SIERRA GEOTECHNICAL SERVICES INC.

Subject: **RESPONSE TO PEER REVIEW**
Phase 2 of Tentative Tract 37-46
White Mountain Estates Subdivision
Chalfant Valley, Mono County, California

Reference: Review Of Earthquake Fault Zone Hazard Evaluation Reports
Tract 37-16 And Phase 2 of Tentative Tract Map No. 37-46
White Mountain Estates Subdivision
Chalfant Valley, Mono County, California
Prepared by AMEC Earth & Environmental dated January 12, 2006

NOTE: REFER TO OTHER LOGS OR REPORT TEXTS FOR DETAILED DESCRIPTIONS OF DENOTED LITHOLOGIC UNITS

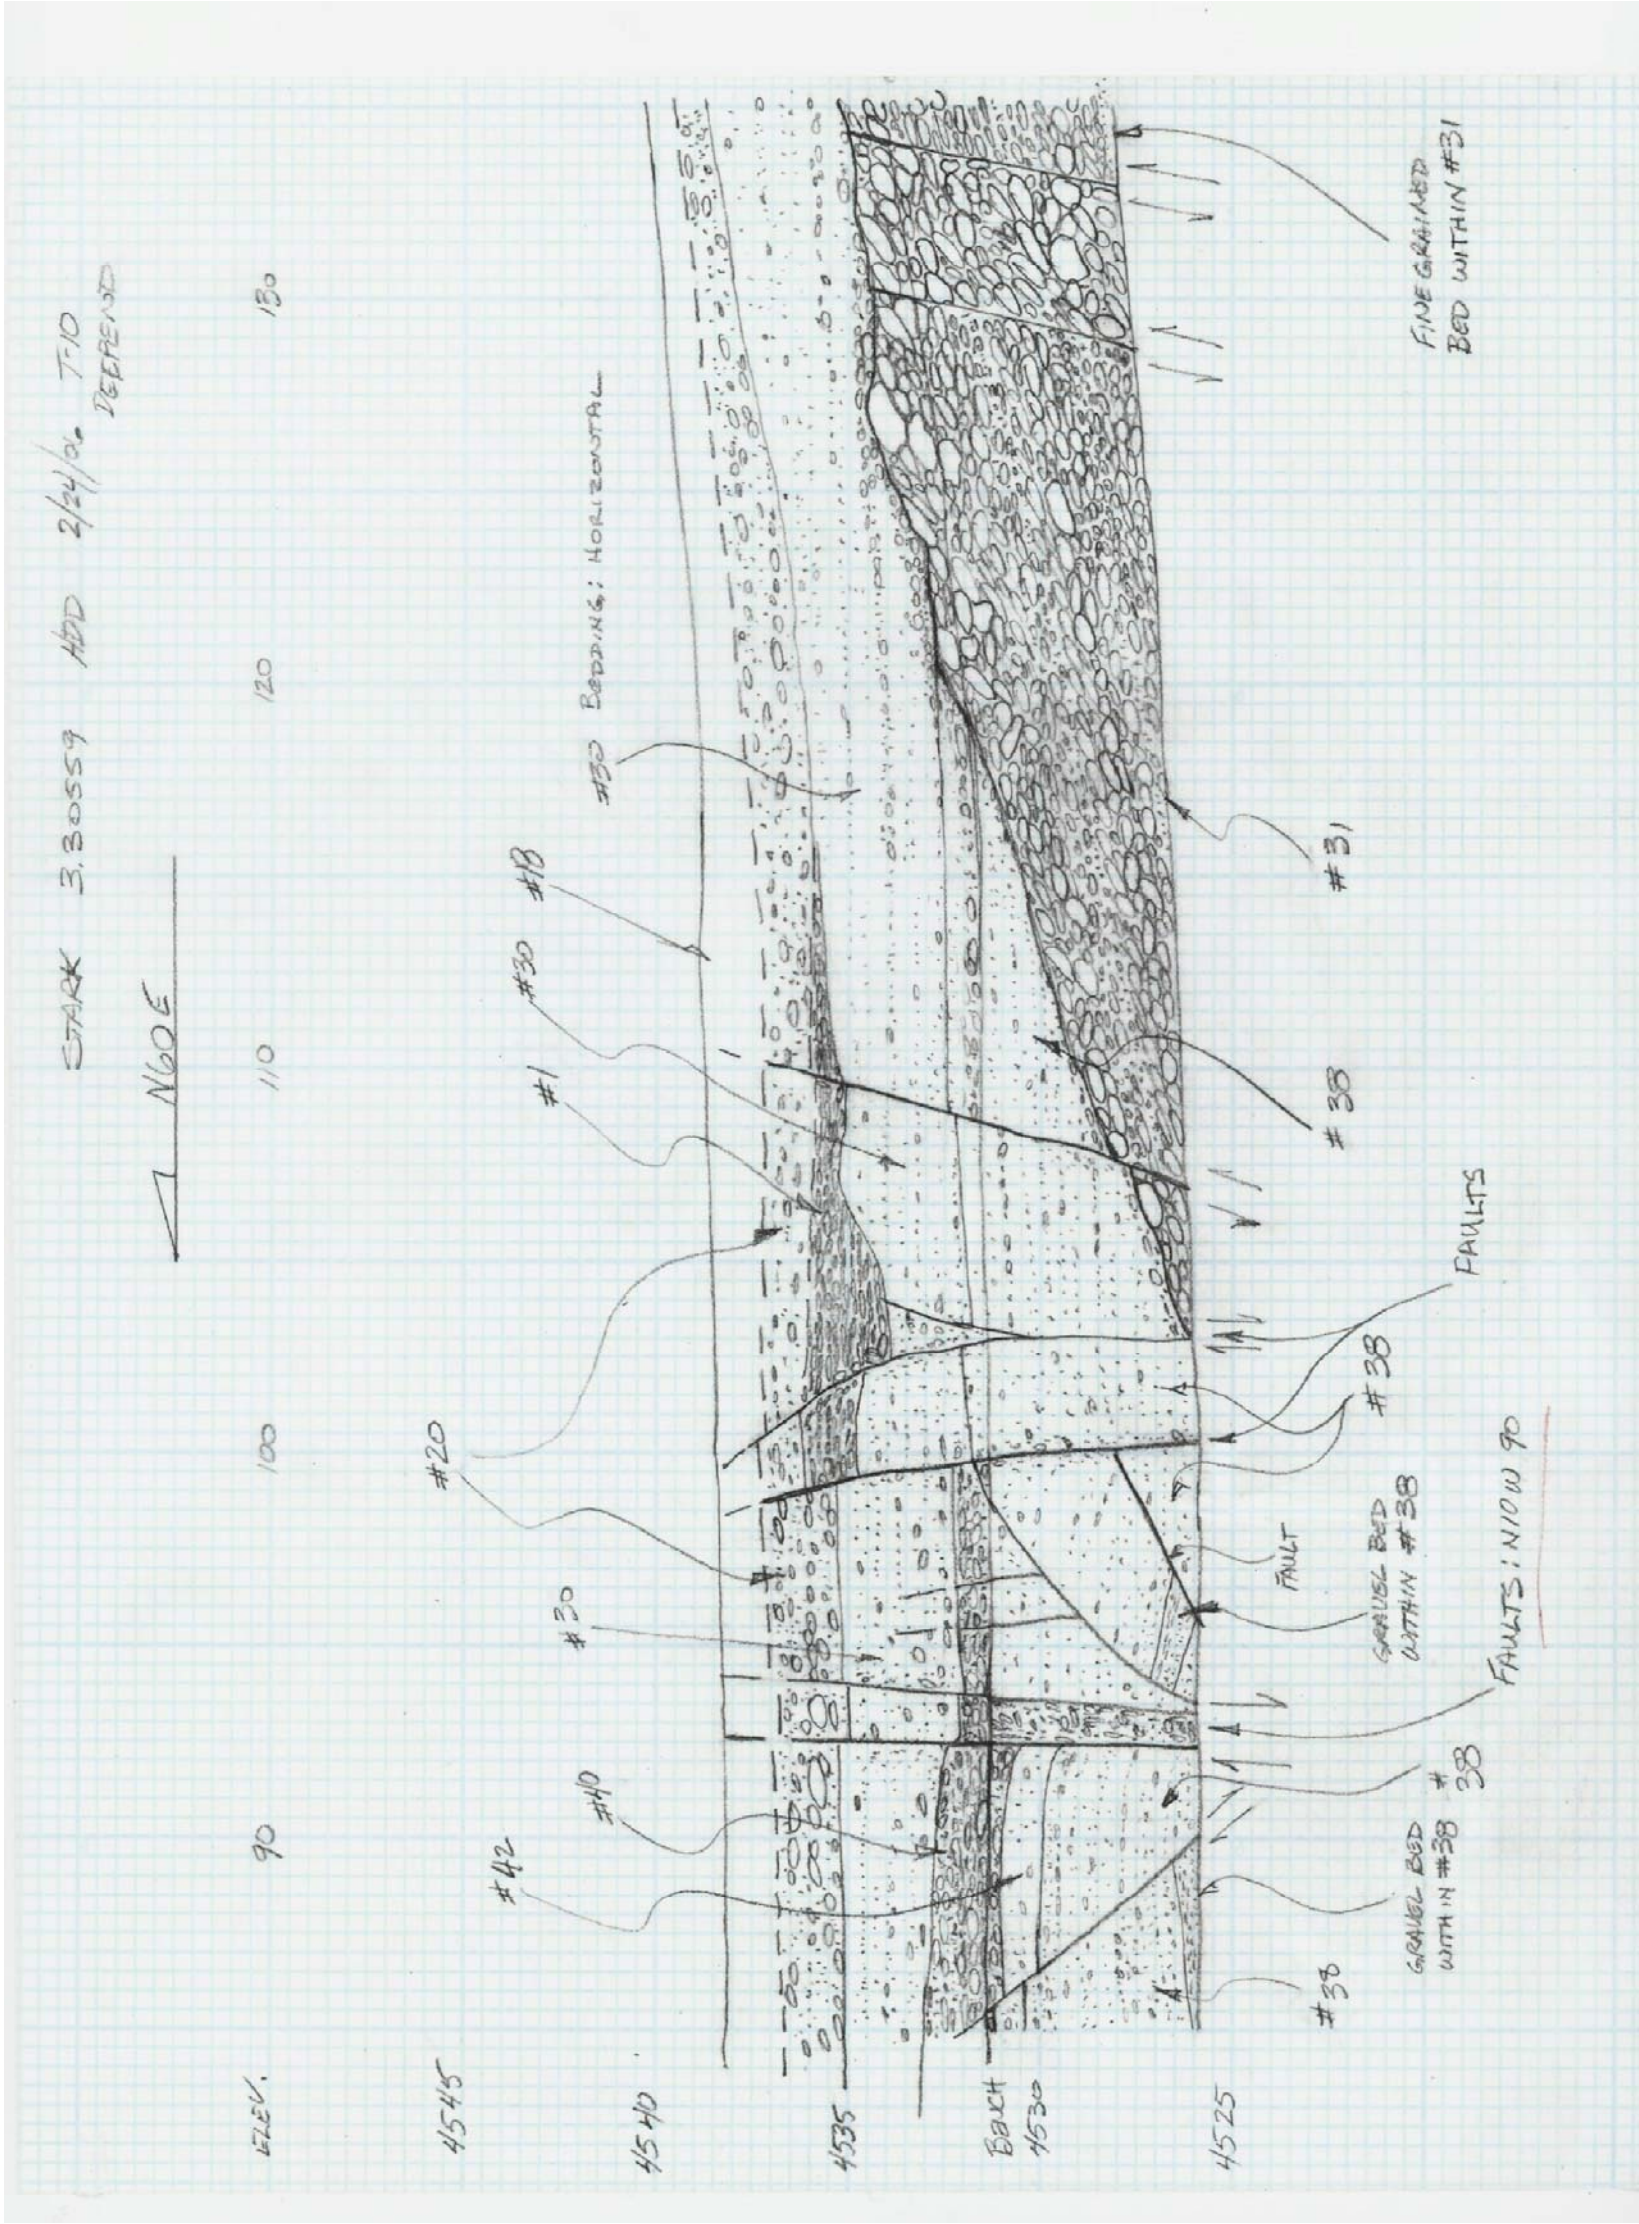
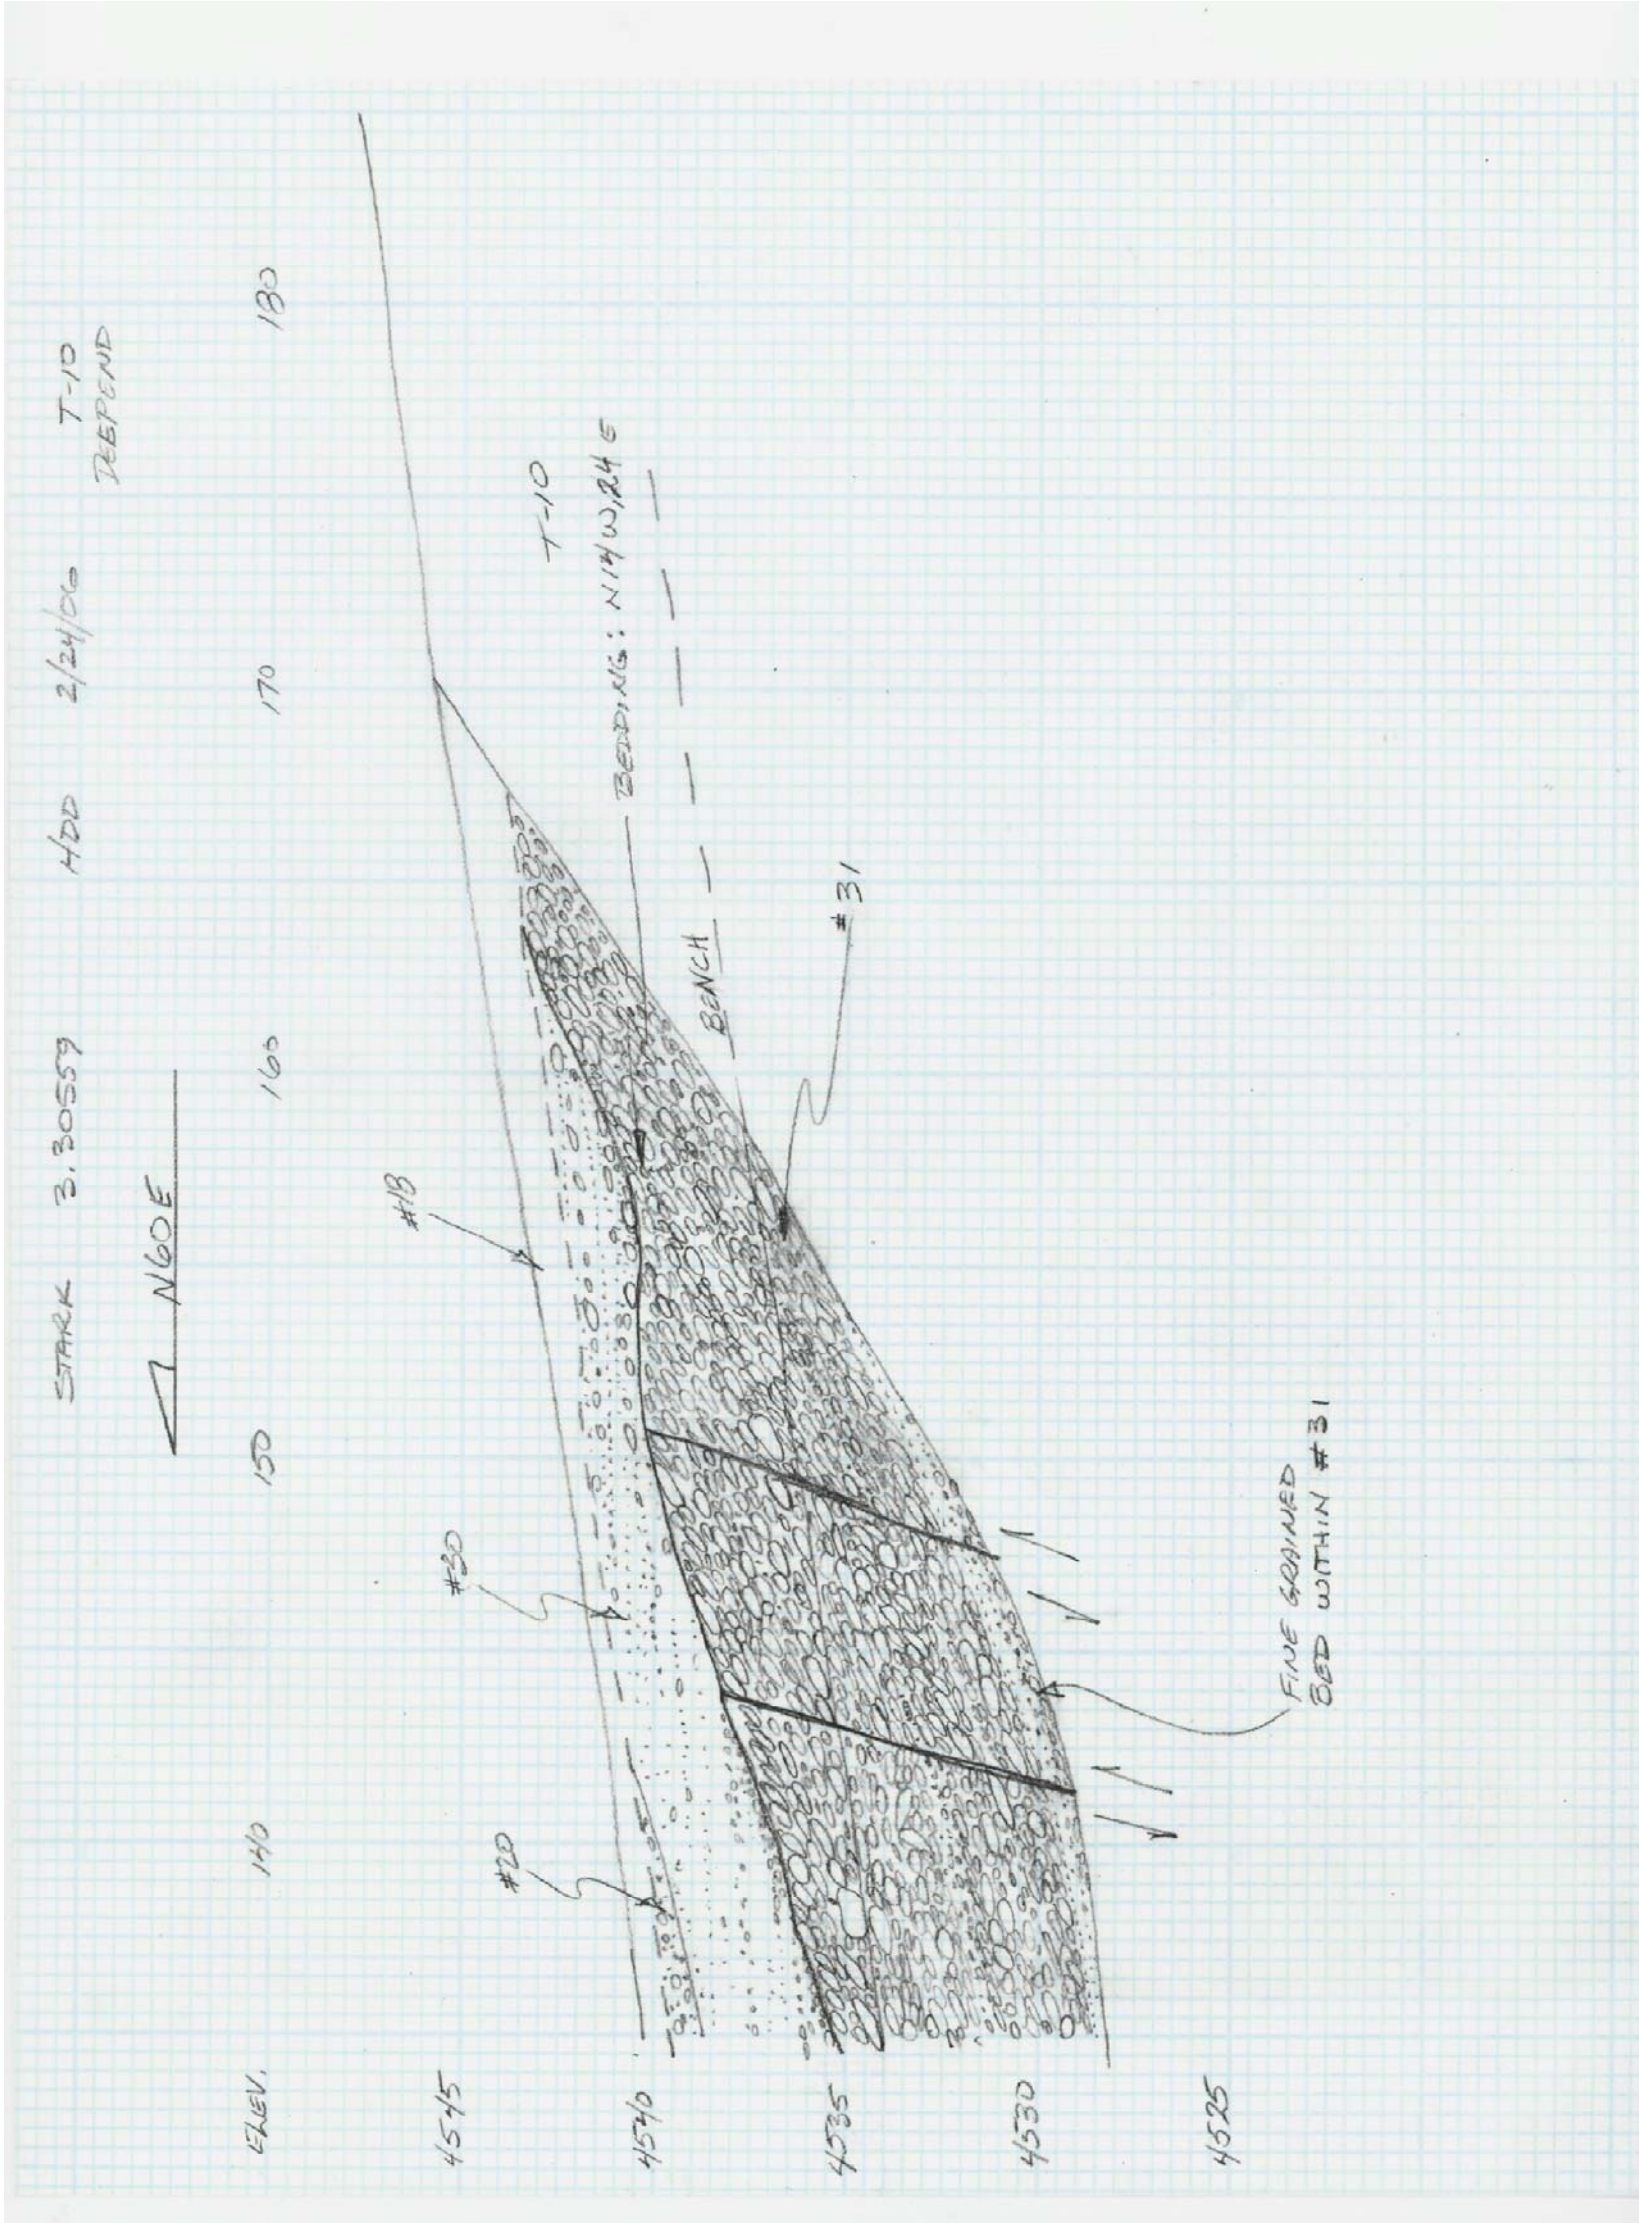
The designated habitable area within Lot 46 is based on the fault related features and their structural orientations as observed and subsequently depicted in the log of Trenches T-10. The geomorphic features mapped within Lot 46 have been designated as Qfo (6), Qfo (7) having respective ages varying from 200,000 to more than a million years old as previously determined by Bruce Schell. The alluvial sediments exposed in the fault Trench T-10 is described by SGSI as being recent to late Pleistocene in age. The designated habitable area within Lot 46 is depicted as an irregular shaped area approximately 250 feet long and 140 [feet] wide.

The westerly portion of Trench T-10 from Station 0+00 to 1+20 is underlain by recent alluvial deposits. The contact base of the Holocene sediments has not been exposed within this portion of Trench T-10 and as such a definitive statement regarding the active faulting cannot be made by the project consultant within this portion of the proposed habitable area. In addition, the attitude of fractures noted cutting through the recent deposits are similar to the orientation of the crossing faults observed in Trench T-2 and T-6. Based on these conditions it is recommended that the proposed habitable area associated with the westerly portion of Trench T-5 not be accepted without deepening of the trench to expose the full section of Holocene alluvial fan deposits, from the contact with the underlying Pleistocene alluvium to the ground surface, that are unaffected by fault related features.

Response: In conformance with the recommendation provided in the comment above, Trench T-10 was re-trenched to expose the full section of the Holocene alluvial fan from the ground surface down to its contact with the underlying older Pleistocene alluvium. Based upon our observations and logging of the deepened exposure, active faulting was observed from Stations 0+50 through 1+10. This find is consistent with tonal lineaments previously observed in our aerial photographic review and with the southward projecting faults found in Trench T-6 to the north. Therefore, the proposed habitable area within Lot 46 is hereby completely removed.
